Final ASP Analysis – Precursor

Accident Sequence Precursor Program – Office of Nuclear Regulatory Research		
Duane Arnold Energy Center	Loss of Offsite Power caused by High Winds during Derecho	
Event Date: 8/10/2020	LER: 331-2020-001-01 IR: 05000331/2020003	CCDP = 8×10 ⁻⁴
Plant Type:	General Electric Type 4 Boiling-Water Reactor (BWR) with a Mark I Containment	
Plant Operating Mode (Reactor Power Level):	Mode 1 (82% Reactor Power)	
Analyst: Christopher Hunter	Reviewer: Mehdi Reisi Fard	Completion Date: 3/4/2021

Figure B-1. Modified SBO-ELAP Event Tree

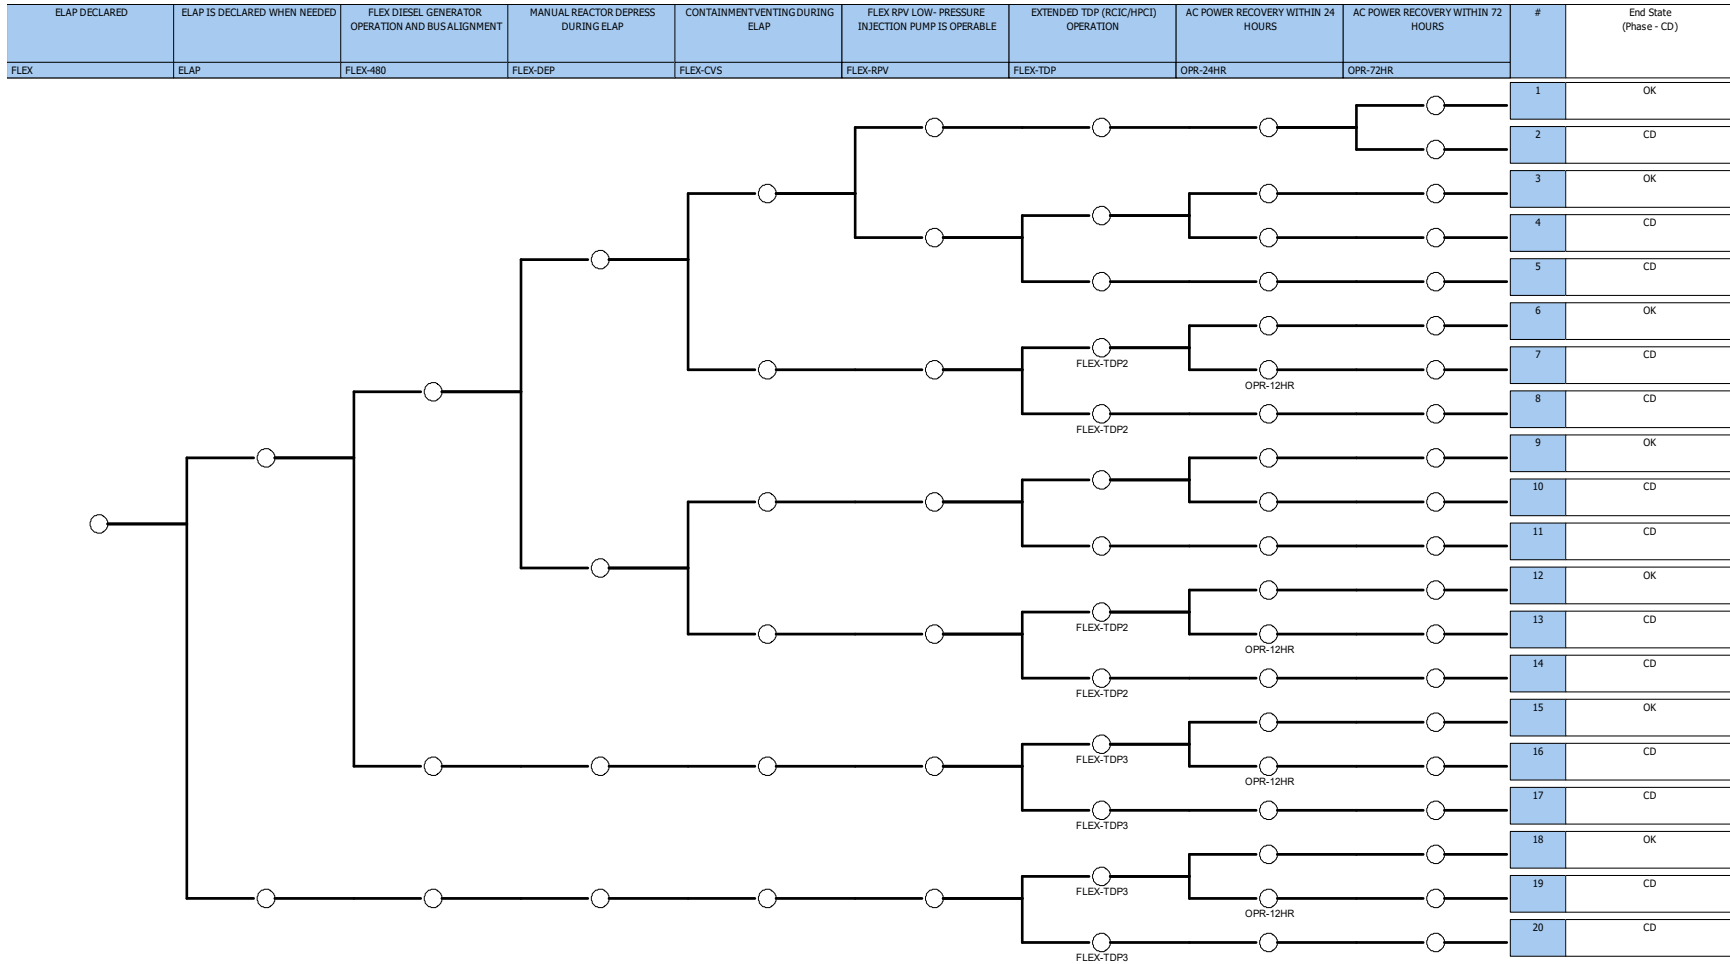
- **Region 3, Section 3.3:** HPCI credit during ELAP and SBO-ELAP event tree changes to query containment venting if reactor depressurization fails. If these model changes are applied for this event, they should be made to other BWR SPAR models.

RES Response/Action: RES will consider similar SPAR model modifications to applicable plants, as appropriate.
